Coal Hollow 5/13/2015 Inspection Report

Inspection Report

Permittee: **ALTON COAL DEVELOPMENT LLC**
 Operator: **ALTON COAL DEVELOPMENT LLC**
 Site: **COAL HOLLOW**
 Address: **463 North 100 West, Suite 1, CEDAR CITY UT 84720**
 County: **KANE**
 Permit Type: **PERMANENT COAL PROGRAM**
 Permit Status: **ACTIVE**

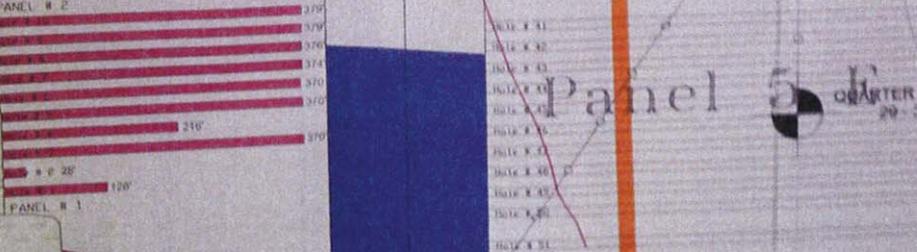
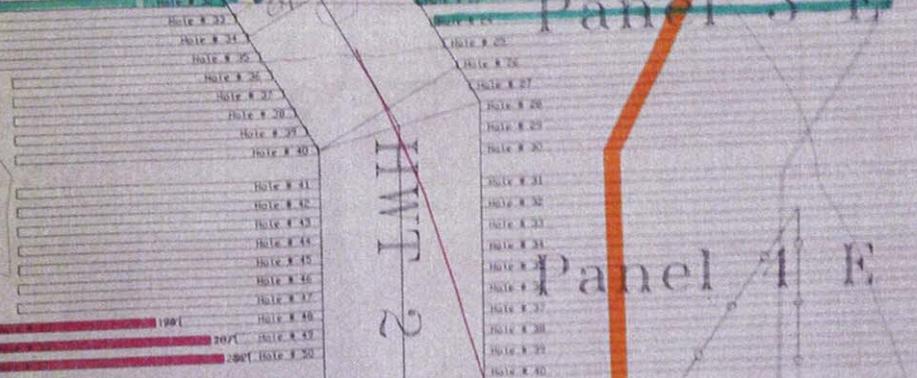
HWT 1 was backfilled above the coal. The haul road/entrance to the HWT 2 face was approximately 1,000 ft. long beginning in HWT 1. Mining activity was focused on construction and extension of HWT 2 where a blast was recently conducted and the overburden had been removed. (See the attached mining progress figure.) The alluvium above this section of HWT2 was being shaped to a 4h:1v slope. The coal in a 200 ft square block was being removed by an excavator and loaded onto haul trucks. This is the first coal to be loaded in a week. Mining activity also focused on construction and face-up of 3 portals in the UG Mine. Four coal haul trucks were running all day hauling gravel and cobbles from a gravel pit south of the mine on the County road to the UG mine/Pit 10 haul road. There was no backfilling occurring.
